From: Richard Dollamore <richard@whaleback.co.uk>
Sent: 22 May 2026 11:45:16 UTC+01:00
To: "Andrew Horrell" <andrew.horrell@midsussex.gov.uk>
Cc: "Joanne Fisher" <joanne.fisher@midsussex.gov.uk>
Subject: RE: DM/25/3072 and 3073 The Coach House, Nether Walstead
Attachments: Ty-Mawr Sublime Literature - 2022.pdf, Indicative Construction Details 1 to10.pdf

Nether Walstead is a Grade II listed building, a former farmhouse which was significantly extended in the early 20th century to form a country house of some pretension. The former farm buildings of the farmstead appear to have been located to the northeast of the house, ranged around a series of yards. A small number of historic buildings survive in this area. The Coach House is a two-storey brick and clad building which appears on historical maps dating from the 19th century and would be regarded as curtilage listed, although it is noted that the structure

Figure 6: Insulating limecrete slab
Where a decision is taken to insulate a historic floor then one option is to provide a permeable insulated floor slab as shown here. Expanded clay is used as the insulant.

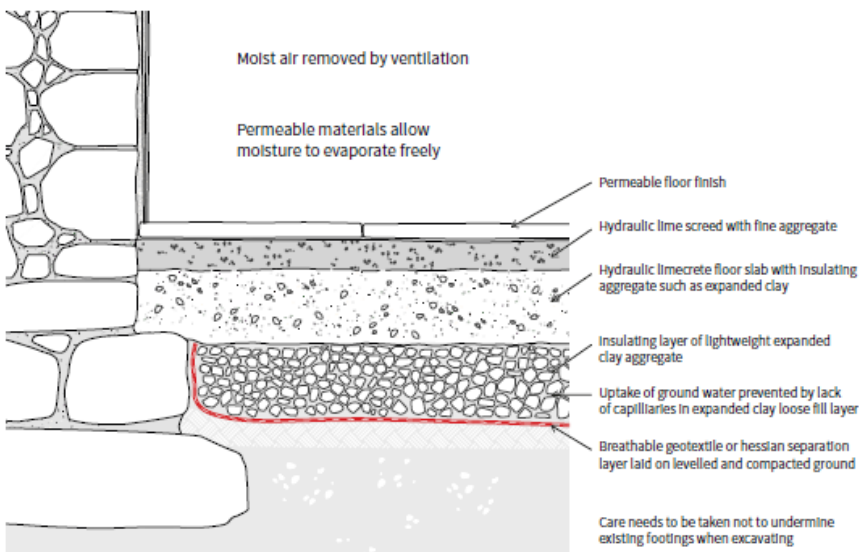
4. Further information should be provided regarding the proposed method of insulation to floor, walls and roof of the building. I would prefer to see this now rather than by condition, as it will be fundamental to the practical implementation of the scheme. We will need to see detailed typical elevations and sections which demonstrate how historic fabric which is of interest, such as the timber framing to the roof and some of the walls of the building, is retained and exposed to view.

Although it is good to note that Historic England guidance will be followed, I am afraid that we do require details to be provided at this stage rather than by condition, for the reasons set out in my initial comments. It is much better that any potential issues with this are identified and addressed now rather than problems arising after a consent is potentially granted and works commenced. This is our standard practice in dealing with conversions of traditional farm buildings of heritage value.

The proposal adopts a breathable floor build-up intended to improve thermal performance while allowing the movement and evaporation of moisture, thereby avoiding the risks associated with impermeable floor constructions in traditional buildings. The attached Ty-Mawr Sublime literature provides further indicative information. A detailed site-specific section and specification can be secured by condition following detailed investigation.
